UPDATED STAFF REPORT

**RE: 3228 Flagler Avenue (3221 Riviera Drive)
UPDATED Sec 108 Landscape Review**

FROM: Karen DeMaria, City of Key West Urban Forestry Manager

THE STUDIOS ON RIVIERA
CODE MINIMUM LANDSCAPE PLANS
KEY WEST, FLORIDA

LANDSCAPE PLAN

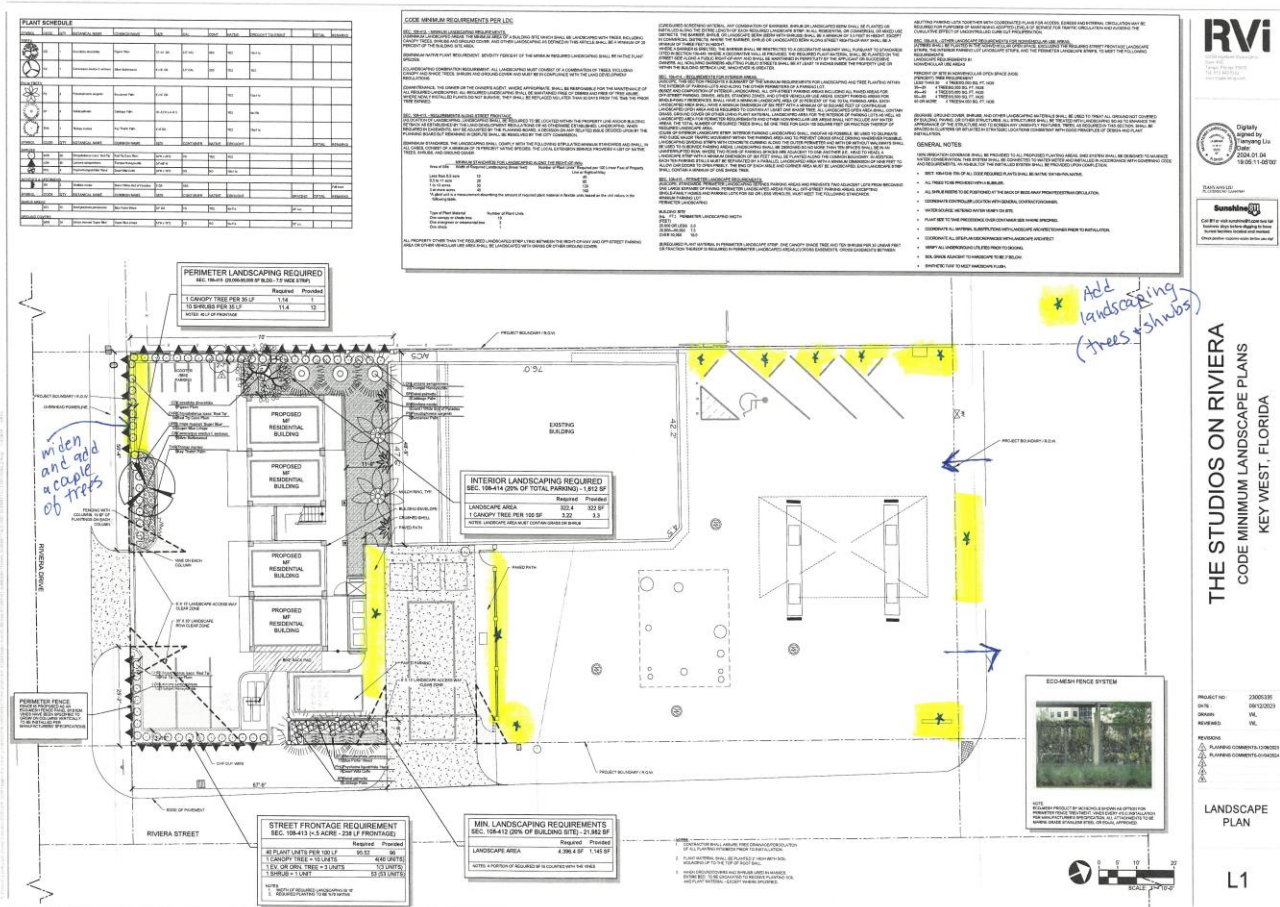
On February 7, 2024, a meeting was held with representatives of the property owner, regarding potential improvements to the landscape plan to increase the proposed open space/landscaping percentage on the property. A 2018 City Commission Resolution approved a 16% open space allotment. The submitted proposal requested a reduction to 8%. A request was made by Planning Staff, to add planters in areas on the gas Station/Convenience Store portion of the property, add vegetation along the existing concrete wall that divides the areas on the eastern property line where the garbage and recycle areas are proposed, and increase the width of the landscape area in the southwest corner of the property (see highlighted site map below).

4. Sec 108-346 (open space): The proposed open space percentage is 8%. City code requires 20%. The 2018 City Commission Resolution approved a 16% open space.

The western property line now appears to have a planned minimum 3.7 ft wide by approximately 30 ft long landscape area next to the scooter parking area that opens to a larger 10.4 ft wide by 40 ft long planter area. The remaining 150 ft of property line includes zero vegetation and asphalt in half the area. A minimum of 37 plant units per 100 linear ft with the installation of an opaque fence is required. This bufferyard, measuring 3.7 ft by 220 ft long, requires a total of 81 plant units. 24 plant units (shrubs) are planned to be planted along the fence line with an Eco-Mesh fence panel system with trumpet "coral" honeysuckle plants. It is not known if this type of fencing is considered opaque.

The western property line buffer area for the new proposed development meets this condition but the remaining bufferyard involving the existing portion of the property technically has no bufferyard. Representatives for the property owner were asked to plant some trees along this property line area in front of the parking spots. The updated plan does not include any additional plants along this bufferyard.

The landscape plan along Riviera Drive, the southern property line area, 100 ft long, proposes to plant a line of cocoplum shrubs (22-plant units) with an eco-mesh fence planted with trumpet honeysuckle (9-plant units) in a 3.1 ft to 4.8 ft wide consistent area. One silver buttonwood tree and blue liriopce groundcover has been added to the landscape plan for this area. An additional 4.4 ft wide by approximately 25 ft long planter area is also being created that includes the planting of (1) Silver Buttonwood, (1) Thatch Palm, and blue liriopce groundcover for a total of 44 plant units.

Rivera Street, the eastern property line area, is a total of 220 ft long and requires 176 plant units in a 20 ft wide area. The landscape plan for the proposed development area includes the planting of (14) Cocoplum shrubs, (9) Trumpet Honeysuckle, (3) Sabal Palms, (9) Wild Coffee, and (15) Blue Porterweed for a minimum total of 61 plant units in a planting area between 3.1 ft to 6.1 ft wide in a 67.9 linear ft area with no vegetation in the remaining 152.1 linier feet. This 152 ft area is primarily asphalt for parking and ingress and egress to the gas station/convenience store.

EXISTING TREE PLAN

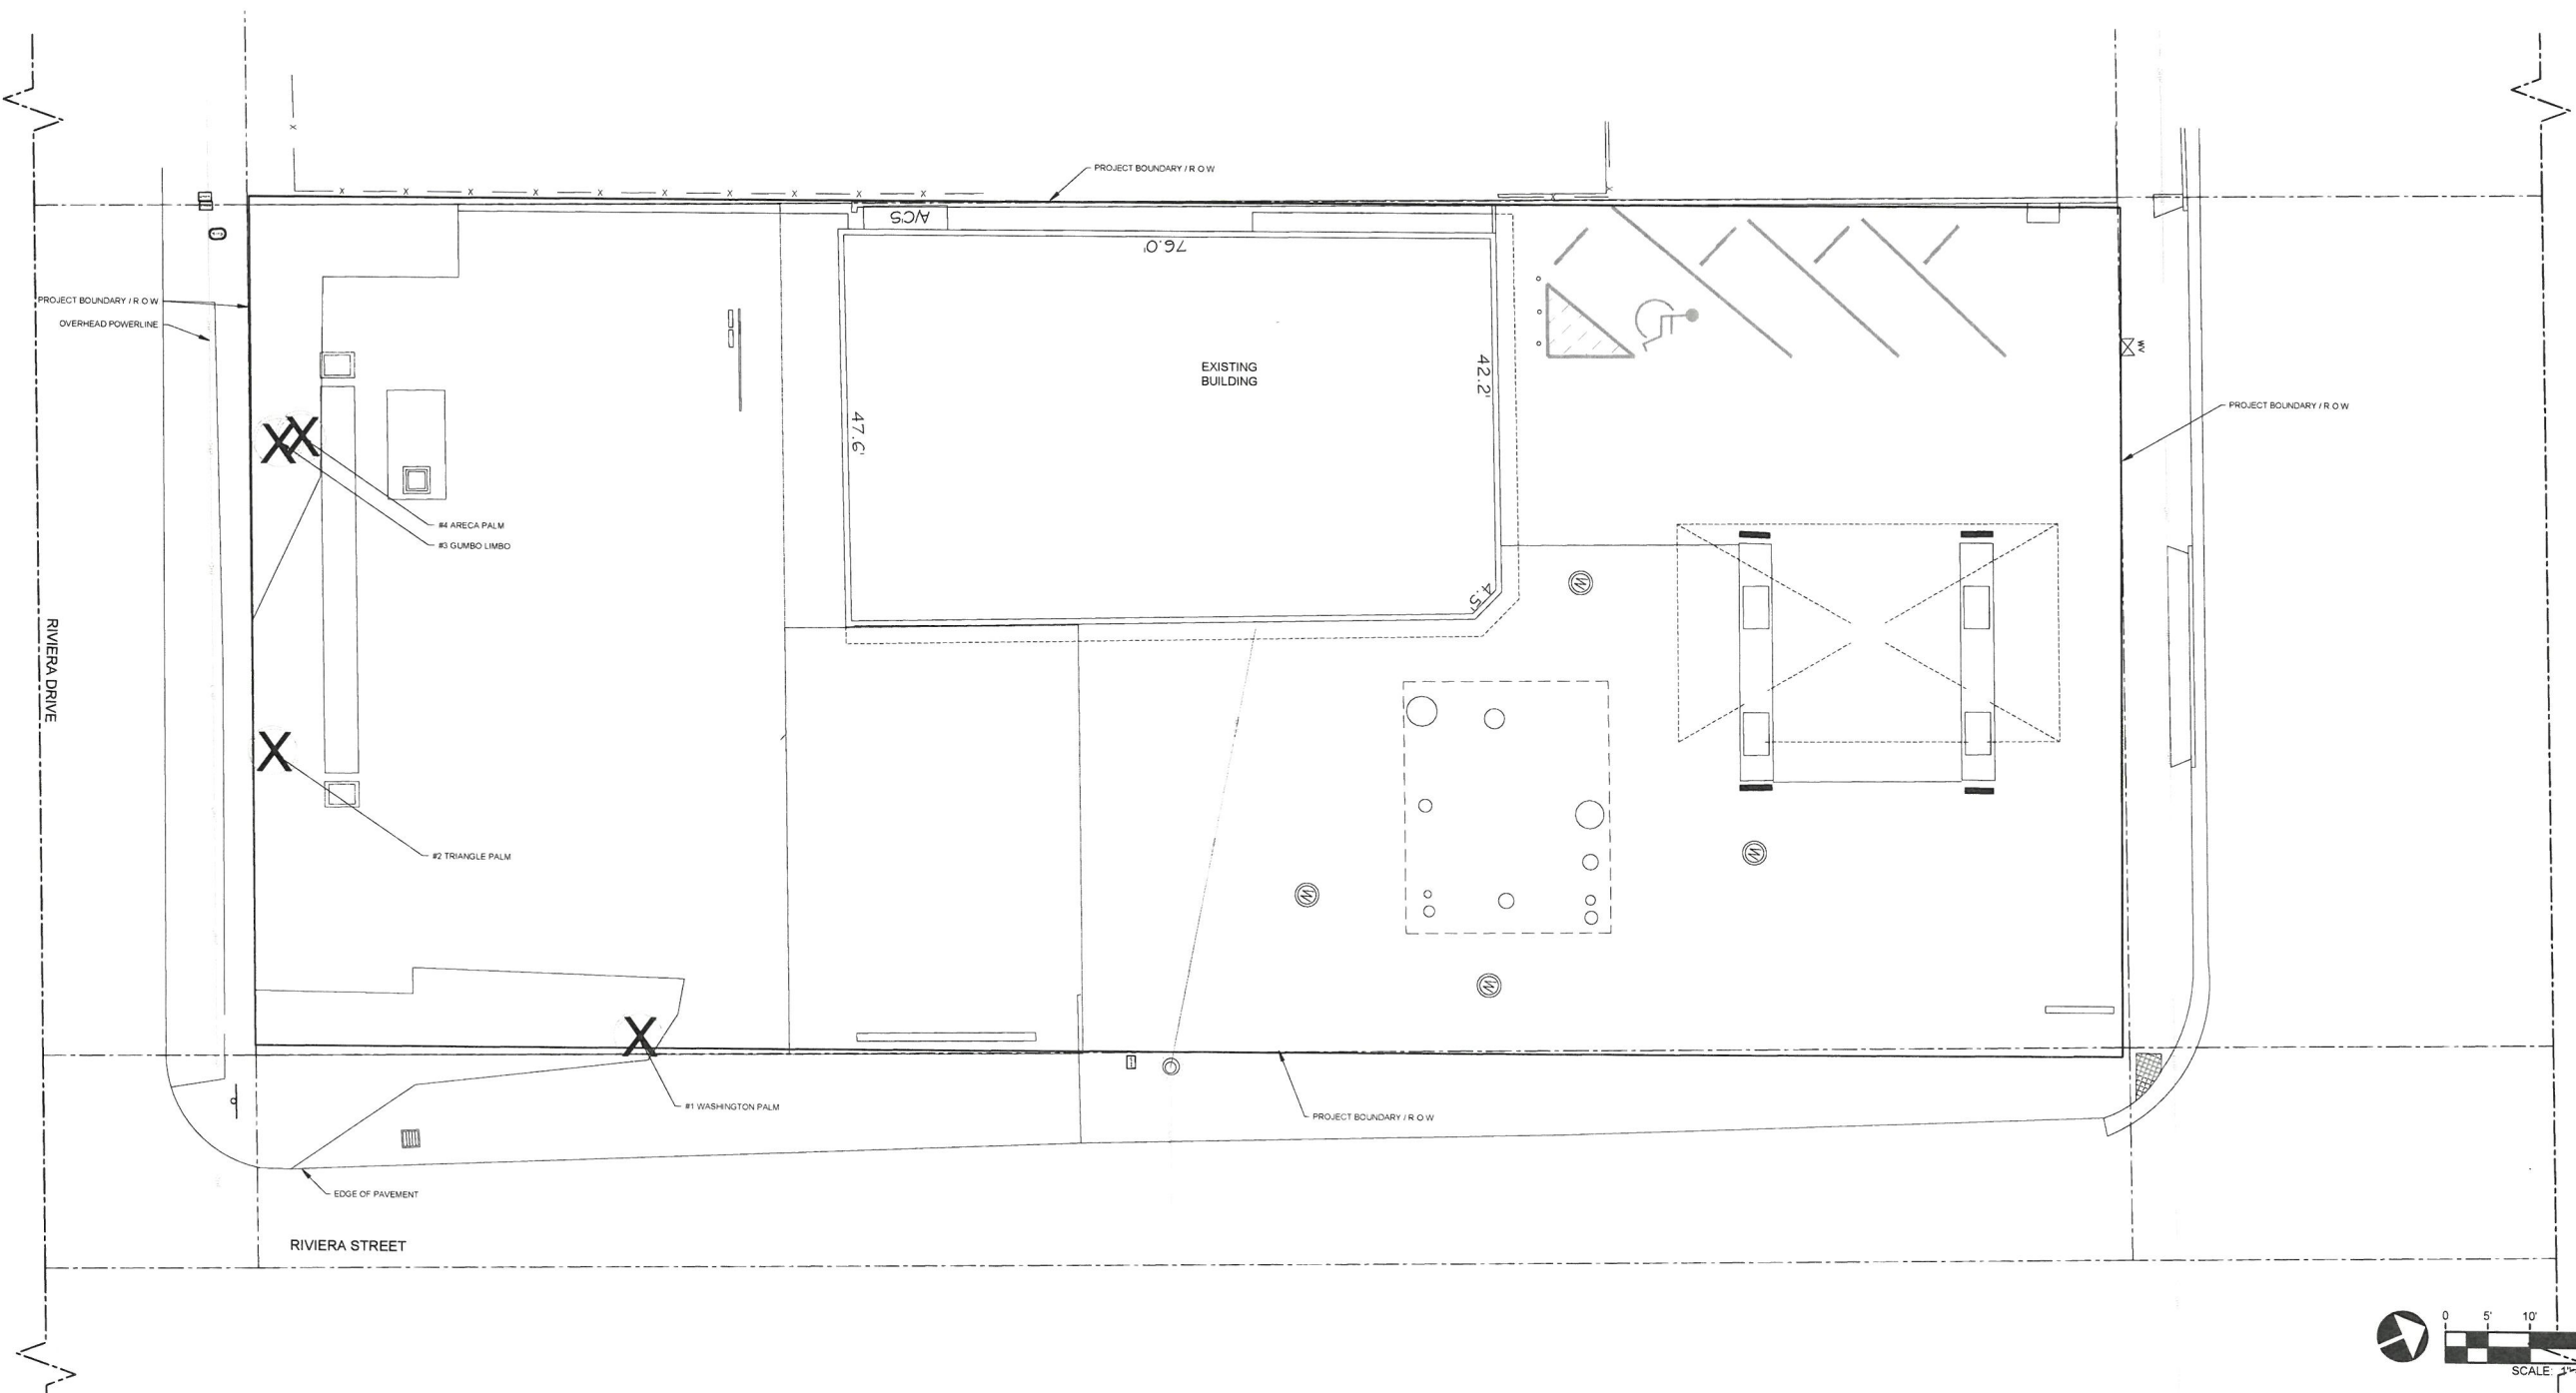
incorrect

1. The property maintenance plan must include continued maintenance of the property to remove any invasive exotic plant species (Brazilian Pepper, Australian Pine, Lead Tree).
2. The existing site map must be updated prior to the Planning Board meeting with corrected information regarding the Gumbo Limbo tree and its removal criteria.
3. Final landscape plan approval required from Tree Commission prior to placement on City Commission agenda. If no significant changes occur to the approved landscape plan, then the Urban Forestry Manager can review for approval.
